# Eck 10th Addition

RE: SUB 2001-81-- Final Plat of Eck Tenth Addition

**REVISED STAFF REPORT**

**CASE NUMBER:** SUB 2001-81 -- ECK TENTH ADDITION

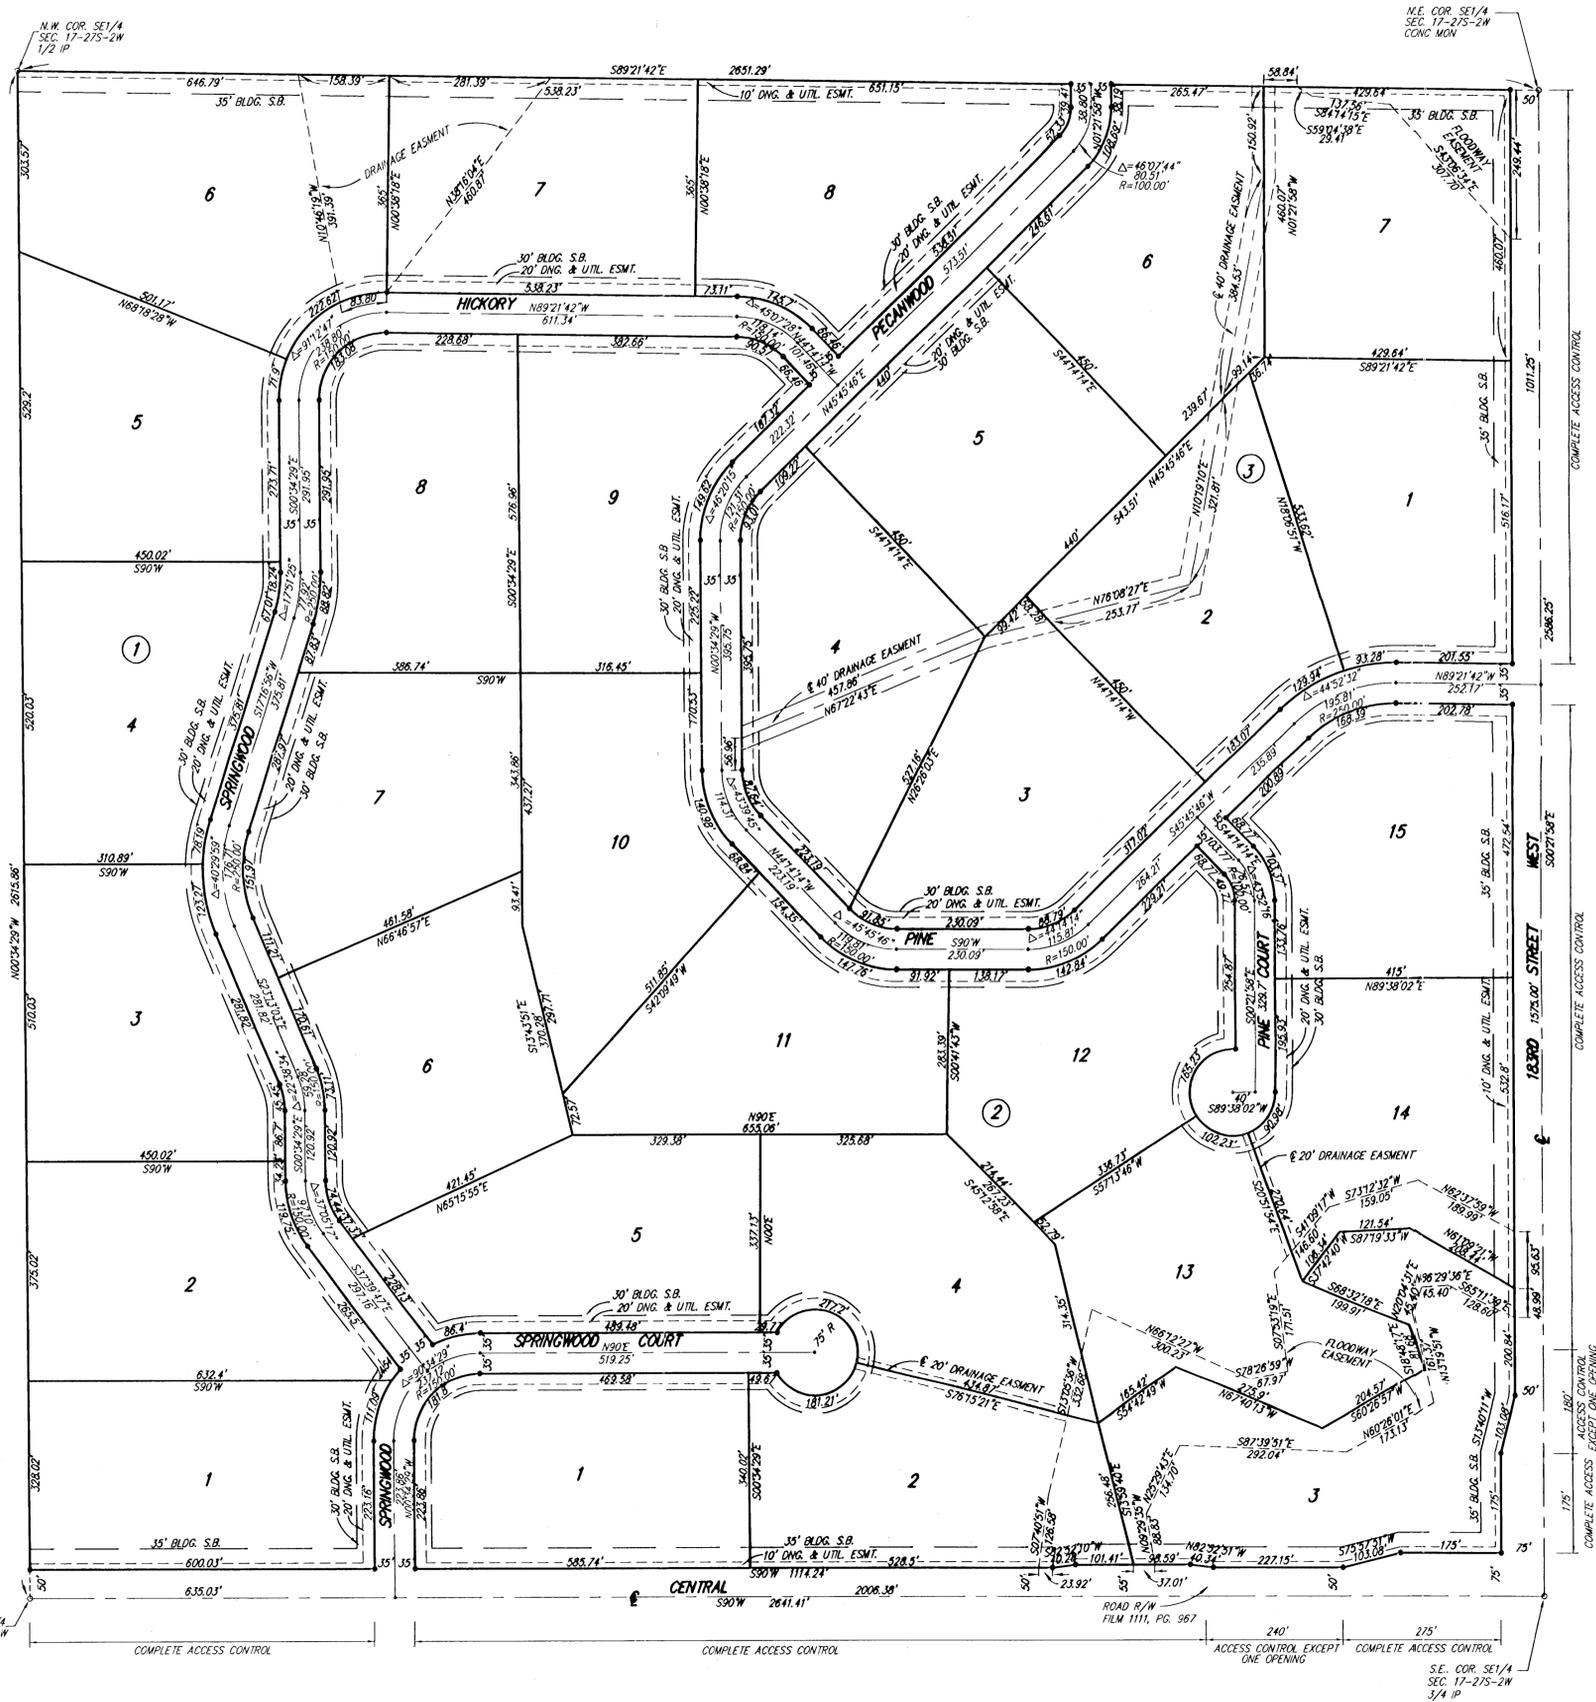
- A. Since sanitary sewer is unavailable to serve this property, the applicant shall contact the Environmental Health Division of the Health Department to find out what tests may be necessary and what standards are to be met for approval of on-site sewerage facilities and water wells. A memorandum shall be obtained specifying approval. *A plot plan is needed for Lots 3, Block 2, and Lot 6, Block 1 to verify buildable area.*

- E. County Engineering needs to comment on the status of the applicant's drainage plan. *Floodway reserve boundaries need to be reviewed. Adjustments to floodway reserves may be required after review of the drainage plan. Minimum pads may be required. Development on Lot 6, Block 1, and Lots 2,3,4,13,14, Block 2, needs to be restricted prior to a letter of Map Revision from FEMA. Drainage easements may need to be increased. A Master Lot Grading Plan is needed.*

- F. County Engineering has required complete access control to 183<sup>d</sup> West for Lot 7, Block 3; access may be obtained from Willow Creek Drive.

- I. The County Fire Department/GIS needs to comment on the plat's street names. GIS has required Autumn Drive be revised to Springwood; extending from the south line of the plat to include the frontage of Lot 5, Block 1. Autumn Drive Ct shall be revised to Springwood Ct. Pecanwood Road shall be revised to Pecanwood extending from the north line of the plat to include the frontage of Lot 10, Block 2. Pine Road shall be revised to Pine.

- GIS has requested the removal of the street names denoted on the abutting property to the north.
- J. Lot 13, Block 2 does not meet the 200-ft lot width requirement which is measured at the building setback line. The lot also does not meet the 100-ft lot frontage requirement. A modification will need to be approved. The Subdivision Committee has approved a modification.

- M. The floodway reserve near the southeast corner of plat needs located with respect to property lines.
- N. On the final plat tracing, the MAPC signature block needs to reference "J.D. Michaelis, Chair".

- O. The plattor's text shall include language that a drainage plan has been developed for the plat and that all drainage easements, rights-of-way, or reserves shall remain at established grades or as modified with the approval of the applicable City or County Engineer, and unobstructed to allow for the conveyance of stormwater.

The requested access controls have been platted.
